CONVERTING THE FD-68 RGB FOR POSITIVE SYNC MONITORS

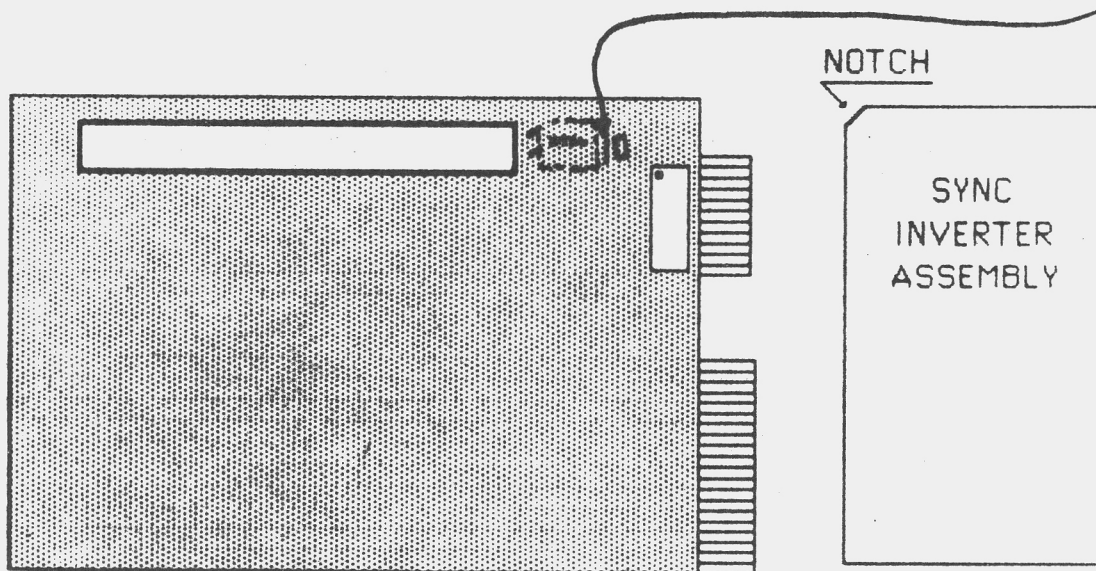
P.S. - POSSIBLE THE PL MONITOR WILL JITTER -
TRY CHANGING THE 100K Ω RESISTOR HERE TO $\approx 39K \Omega$

REMOVE THE LS-367 AND REPLACE WITH
THE ENCLOSED ASSEMBLY.

INSERT ASSEMBLY WITH THE NOTCH AT
THE SAME CORNER AS THE DOT. IF YOU
RE-INSTALL THE LS-367, BE SURE TO
PLACE IT IN THE SAME DIRECTION.
